AIR - HP/LP TURBINE ACC SYSTEM - ADDITION OF ANTI-ROTATION SLEEVE TO THE HPT/LPT ACC
AIR VALVE - CATEGORY CODE 5 - MOD.ENG-75-0031

V2500-ENG-75-0031

V2500 SERIES ENGINES HPT/LPT ACC AIR VALVE ASSEMBLY, PART NUMBERS 5860016-119 THROUGH 5860016-122. UPGRADE TO 5860016-123 THROUGH -126.

Fig.1 (Sheet 1 of 2)

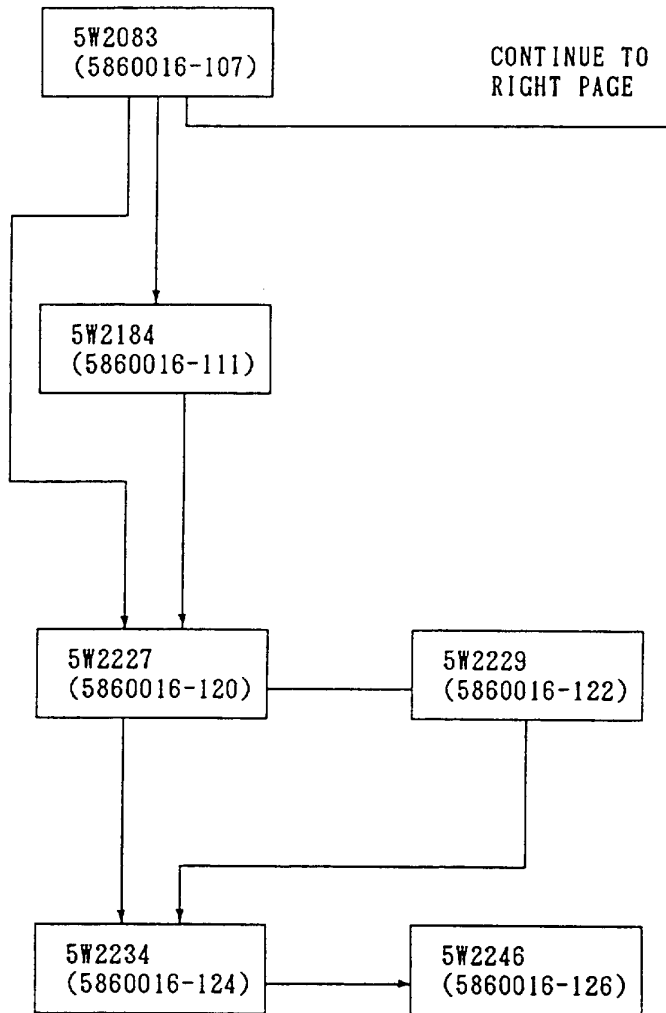
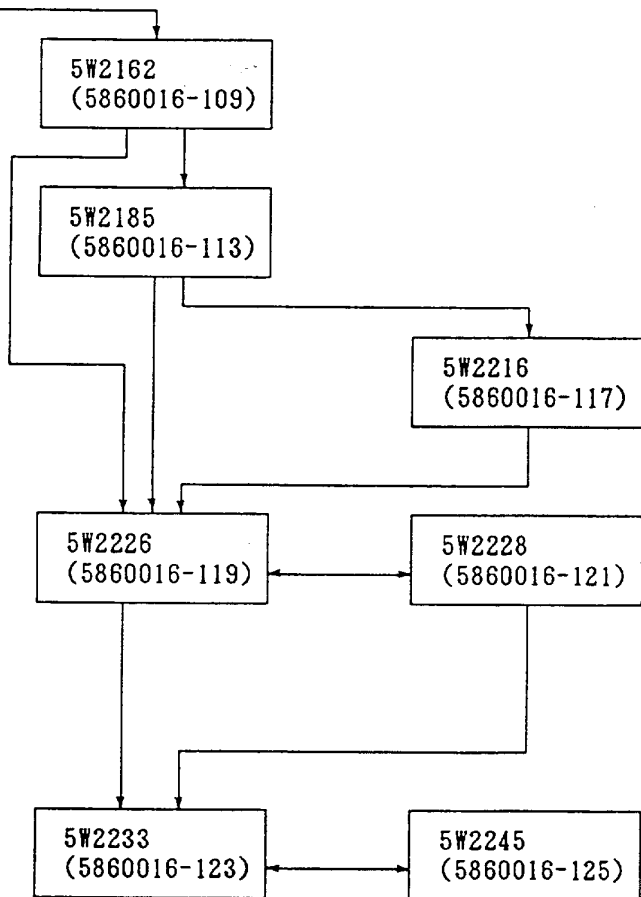
- (a) 5W2233 (Vendor Part Number 5860016-123), 5W2234 (5860016-124), 5W2245 (5860016-125) and 5W2246 (5860016-126) HPT/LPT ACC Air Valve supersede 5W2226 (Vendor Part Number 5860016-119), 5W2227 (5860016-120), 5W2228 (5860016-121) and 5W2229 (5860016-122). A part number family tree chart, Figure 1, shows relationship between the part number and the modifications.
- (b) Shape of sleeve bearing mating position of the valve actuator rod is changed from a right circular cylinder to a rod with parallel faces. A bush with parallel faces is added to the inside of ACC valve tube assembly to prevent rotation of the rod.

V2500-ENG-75-0031
ANTI-ROTATION SLEEVE ADDED:
RELATIONSHIP BETWEEN PART
NUMBER AND PLUG POSITION IS
SAME AS V2500-ENG-75-0021

Rod End Adjustment
Figure 1

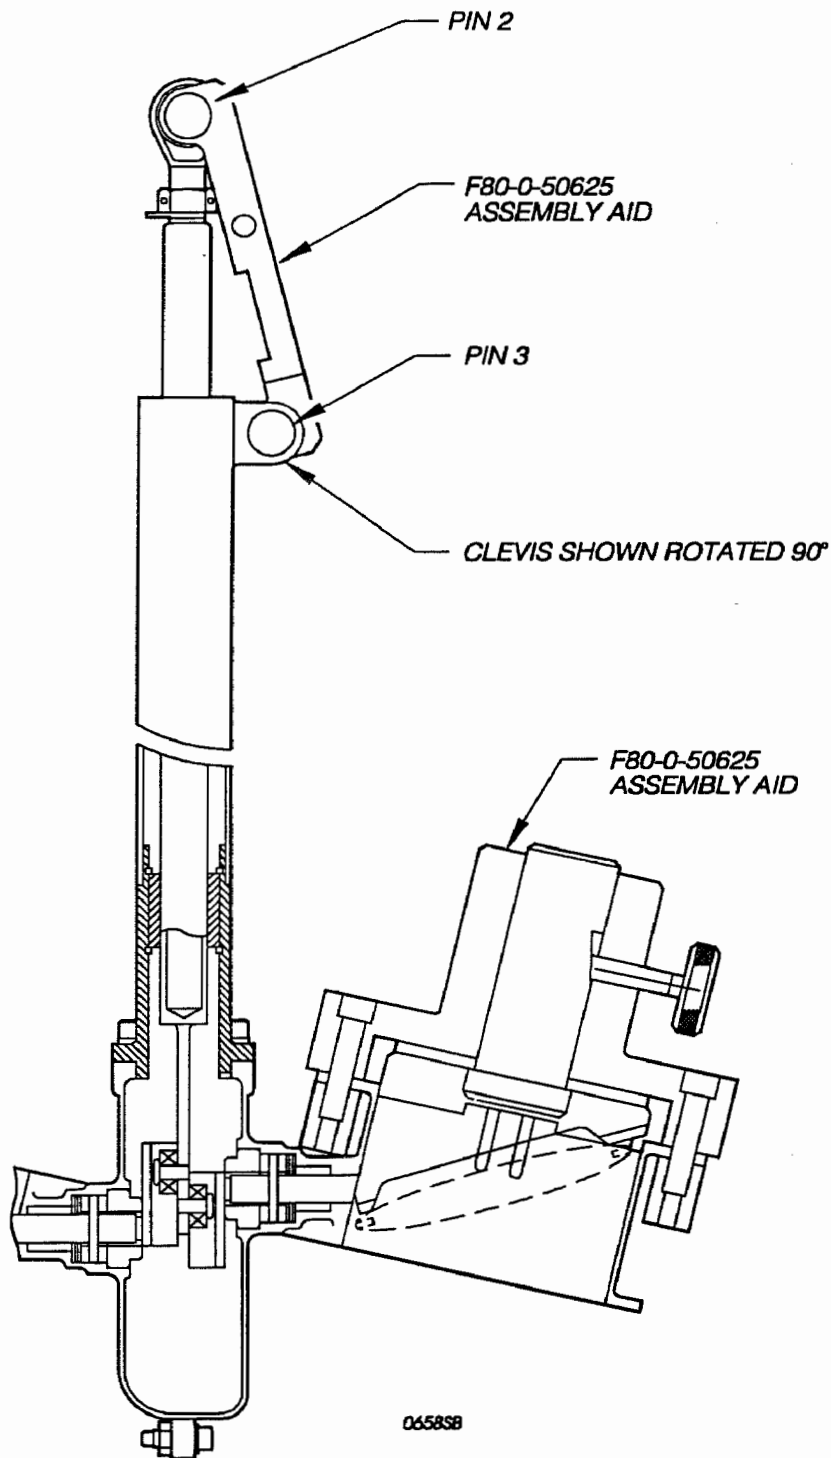
- (8) Install lock washer (15), jam nut (10), and rod end assembly (5).
- (9) Rod end adjustment (See Figure 1)
 - (a) Install assembly aid, F80-0-50623, to inlet side of HPT body assembly (265).
 - (b) Adjust HPT vane (110) to an angle of 30 degrees, 36 minutes and clamp vane in position using thumb screw.

- (c) Install adjustment aid, F80-0-50625, to clevis end of tube and fitting, part number 5903376-101, using pins.
- (d) Adjust rod end (5) 3.366 to 3.388 inches (85,496 to 86,055 mm).

- (e) Verify that tang of lock washer (15) is in groove of actuator rod assembly part number, 5903375-101.
- (f) Torque jam nut (10) to 60 to 70 inch pounds (6,8 to 7,9 N·m).
